MANDATORY SERVICE BULLETIN NO. MSB F4-039 REV. 0

Type: DA 40 F

Replacement of baggage nets with defective buckles.

Figure 1 - Baggage net installation.

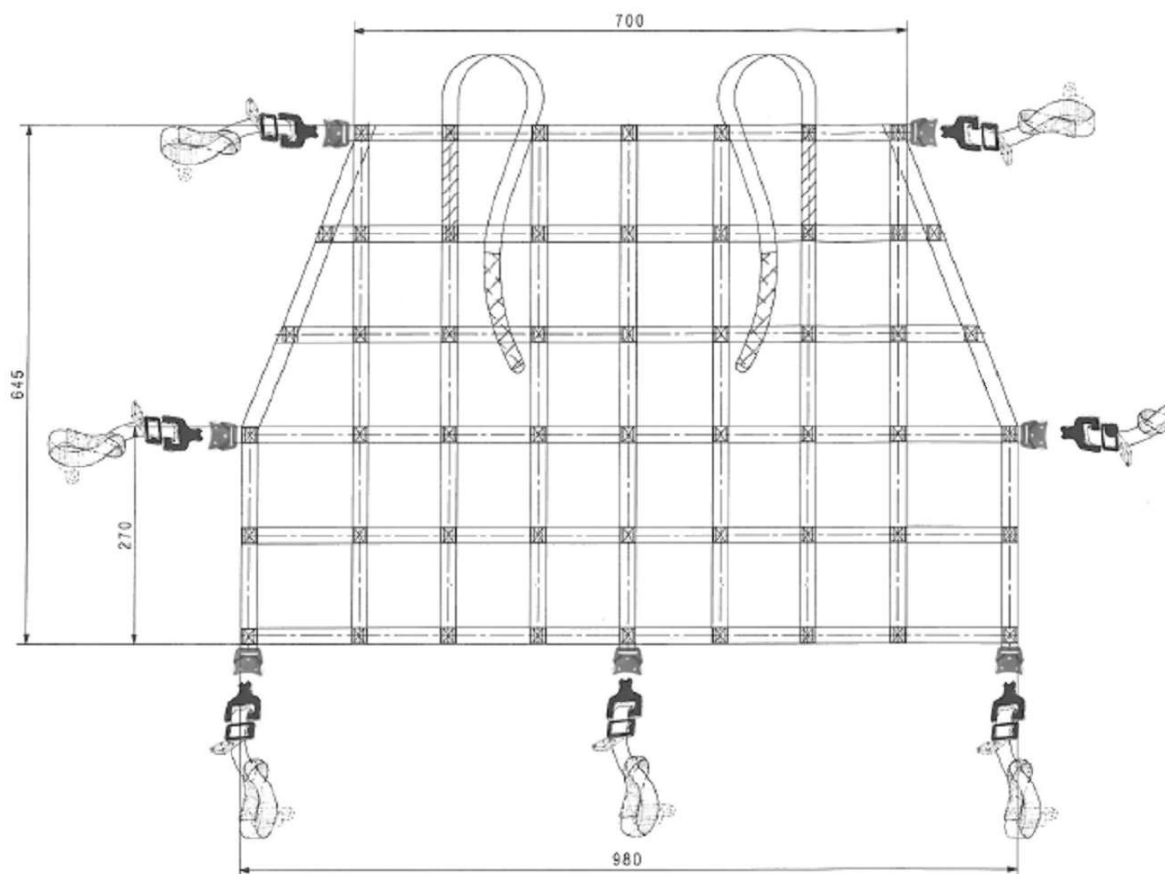
It has come to Diamond's attention that baggage nets with defective buckles have been installed on several aircraft due to a quality escape. These defective buckles may not maintain sufficient holding force and could pose a hazard to the passengers and crew. Effective immediately, these cargo nets are not to be used. Diamond will provide replacement nets to all those affected.

1. Refer to Section I.2. Identify if the baggage net in the aircraft is an affected net. Use the part number and date of manufacture to identify the net.
2. If an affected net is installed, clearly mark the currently installed net as defective, and remove it from the aircraft.

3. Destroy the removed baggage net, or return it to Diamond Aircraft Industries.
4. Install the new baggage net provided by Diamond Aircraft Industries.

Quick Fix Baggage Net Assy - P/N D44-2550-90-00, OR

Cargo Systems Inc. Baggage Net - P/N CS-DA40-1
